911 GT3 Cup (991)

ABS - Entlüftungsstück auf Dichtheit prüfen

ABS – Inspection of Blanking Plug Seal

Fahrzeug / Vehicle:	911 GT3 Cup (991 II)
Bauteil / Part:	Verteilungsstück HBZ / Distributor Piece BMC
Modell / Model	2018

Entlüftungstück / *Blanking plug*

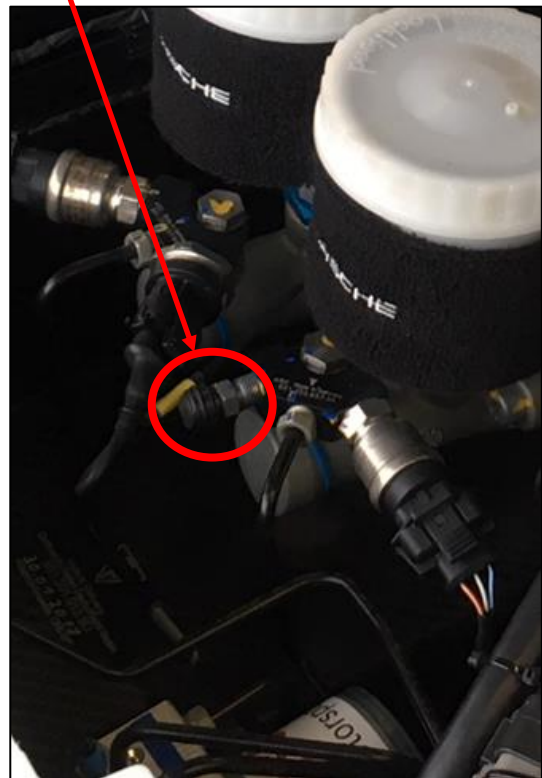
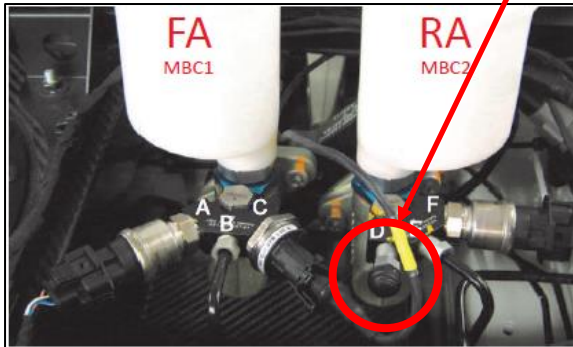
Porsche Motorsport empfiehlt vor dem nächsten Betrieb des genannten Fahrzeuges (ausgestattet mit dem ABS Kit von Manthey – Racing), das Entlüftungsstück am Hauptbremszylinder der hinteren Achse (Fahrtrichtung links) auf Dichtheit zu prüfen. Das betroffene Entlüftungsstück, das am Verteilungsstück des Hauptbremszylinders (HBZ) angebracht wird, ist unten in den Bildern rot eingekreist. Eine Undichtigkeit jeglicher Art ist unverzüglich bei Manthey – Racing an aftersales@manthey-racing.de zu melden.

Porsche Motorsport recommends inspecting the blanking plug for leaks on any of the aforementioned vehicles equipped with an ABS kit from Manthey – Racing before the next operation. The blanking plug is attached to the brake master cylinder (BMC) for the rear axle (left in the direction of travel), and is shown circled in red in the images below. Any form of leaks or poor sealing is to be promptly addressed to Manthey Racing at aftersales@manthey-racing.de.
